**MONITORING YEAR 5  
ANNUAL REPORT**  
Final

**FOUST CREEK MITIGATION SITE**

RE: Draft Monitoring Year 5 Annual Report Comments - Foust Creek Mitigation Site (DMS #95715)  
Cape Fear River Basin 03030002, Alamance County  
Contract No. 004954

**Reachwide and Cross Section Pebble Count Plots**

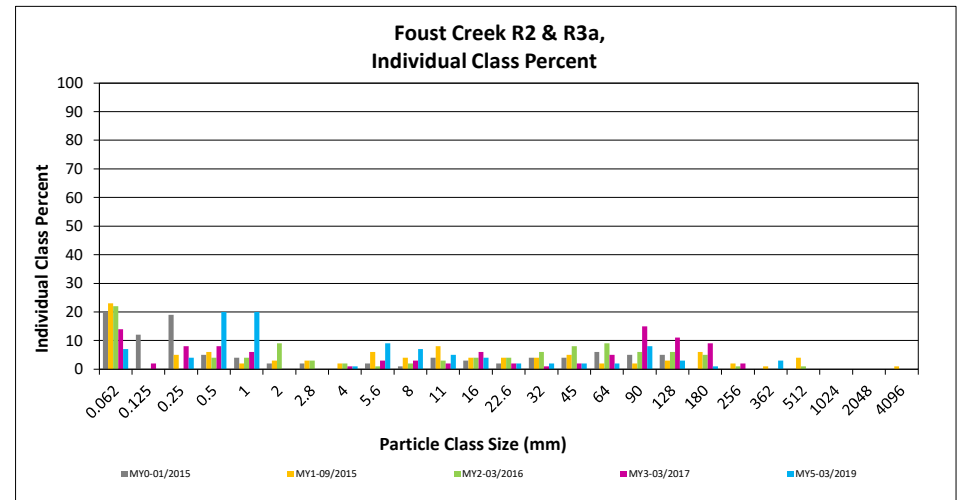
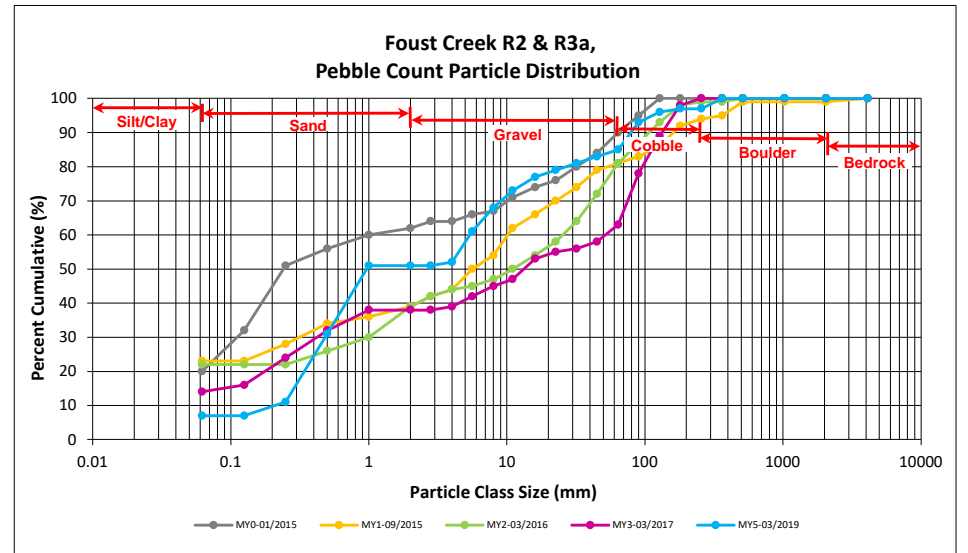
- d. Reachwide and Cross Section Pebble Count Plots – Please change the pebble count sheet titled “Foust Creek R2, Reachwide” to “Foust Creek R2 & R3a, Reachwide” or otherwise indicate that this pebble count includes Reach 3a in order to reduce confusion. Please change “Foust Creek R3, Reachwide” to “Foust Creek R3b, Reachwide.”

*The pebble count plot previously titled "Foust Creek R2, Reachwide" was updated to "Foust Creek R2 and R3A, Reachwide." The pebble count plot previously titled "Foust Creek R3, Reachwide" was updated to "Foust Creek R3B, Reachwide."*
